**Supplementary Information from AAHK on 3RS EIA Report to ACE EIASC Secretariat
On Water Quality, Landscape and Visual and Waste Management**

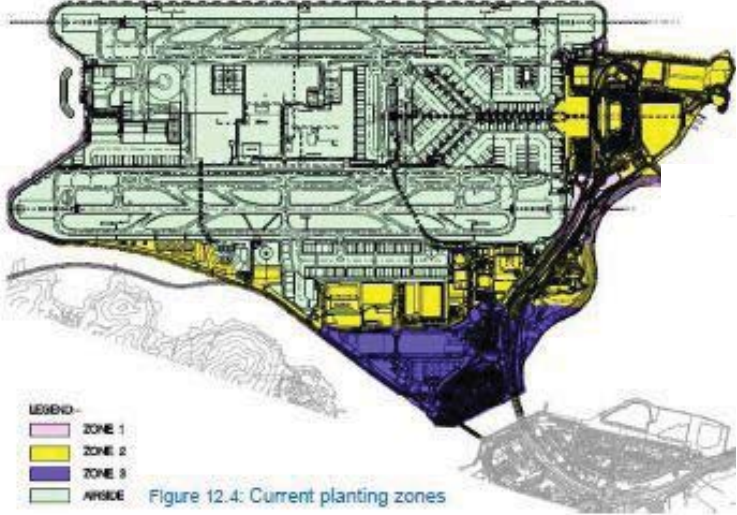
<p>➤ Information on the full list of pollutants and contaminants (including TKN and zinc) collected by the storm water surface runoff; assessment on the potential impacts of such pollutants on marine life</p>	<p>As detailed in Section 8.7.2.48, aircraft maintenance and washing areas are equipped with separate drainage systems to collect, treat, and/or to eventually discharge into the foul sewer, hence do not contribute to stormwater discharge, while the aircraft apron and fuelling areas are equipped with an oil interception system including a spill trap containment system, to prevent stormwater runoff carrying fuel oils into the marine environment.</p> <p>Aside from these activities, there is no substantial difference between runoff from airport paved areas, and runoff generated by typical urban paved areas. Hence there is no reason to expect significant</p>	<p>Table 8.17, Section 8.5.2.5, 8.7.2.48, 8.7.2, 8.8.2.3</p>

Item no.	Comment	Responses	Relevant Sections in EIA Report
		<p>concentrations of heavy metals and other contaminants in stormwater runoff from the airport. The water quality parameters and results from the non-statutory marine environmental monitoring conducted for HKIA is presented in Table 8.17 of the EIA report. Zinc has not been monitored as part of the non-statutory monitoring.</p> <p>As stated in Section 8.5.2.5, discharge of stormwater may contribute a pollution load to the marine environment, and pollutants typically found in stormwater runoff include sediment, heavy metals, synthetic organics and pesticides, which are generated from potentially polluting activities including maintenance, fuelling, etc.</p> <p>With reference to EPD's pilot study on urban stormwater pollution, the main pollutants in stormwater runoff from urban drainage are SS, BOD, and to a certain extent, nutrients. Concentrations of other contaminants such as heavy metals and organics in stormwater from urban drainage are low in comparison (lower than levels permitted under the Technical Memorandum on Standards for Effluents Discharges into Drainage and Sewerage Systems, Inland and Coastal Waters) hence the major concern when assessing impacts of stormwater discharge in previous approved EIAs has been the SS, BOD, and nutrient concentrations in stormwater discharge. Consequently, these parameters were the focus of the water quality impact assessment for this project (results presented in Section 8.7.2) and the findings show no exceedances of the relevant water quality criteria due to the project, hence no adverse impacts on marine life.</p> <p>It may also be noted that contaminants such as heavy metals, by their chemical nature, would be strongly adsorbed onto particulates rather than occur in dissolved (aqueous) form. As stated in Section 8.8.2.3, one of a number of measures to be applied to minimise contaminants in runoff include installation and maintenance of roadside gullies to trap and remove silt and grit from stormwater. These measures are already in place for the existing 2RS and the findings from the non-statutory marine environmental monitoring conducted for HKIA has generally shown that SS levels at the impact stations are similar to or lower than that of the control stations, which demonstrates the effectiveness of these measures. It can thus be expected that the similar provision of such measures under the 3RS (which would follow the same drainage design principles as 2RS) would significantly reduce the amount of SS released into the marine environment, and thereby also reduce the associated pollutants that may be adsorbed to the SS.</p>

View at Central Courtyard

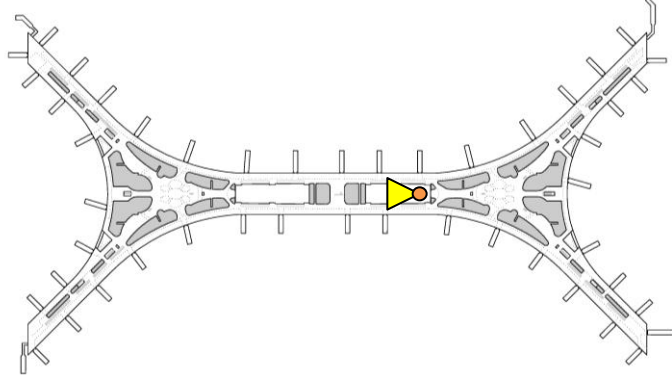
Item no.	Comment	Responses	Relevant Sections in EIA Report
		<p>[OM9] "All streetscape areas and hard and soft landscape areas disturbed during construction shall be reinstated to equal or better quality (due to implementation of screen planting, road verge planting etc.) to the satisfaction of the relevant government departments.": The requirement is that 100% of disturbed areas shall be reinstated. The exact area that will be disturbed shall be minimised as far as practical and is estimated at approximately 16ha (this includes hardscape and softscape).</p> <p>[CM10] "Land formation works shall be followed with advanced hydroseeding around taxiways and runways." The area of airside soft landscape to be grassed is estimated at 270 ha. Grass species shall be selected so as not to attract birds.</p>	
	<p>➤ To provide photo montage(s) for the landscape design</p>	<p>Please refer to Annex 1.</p>
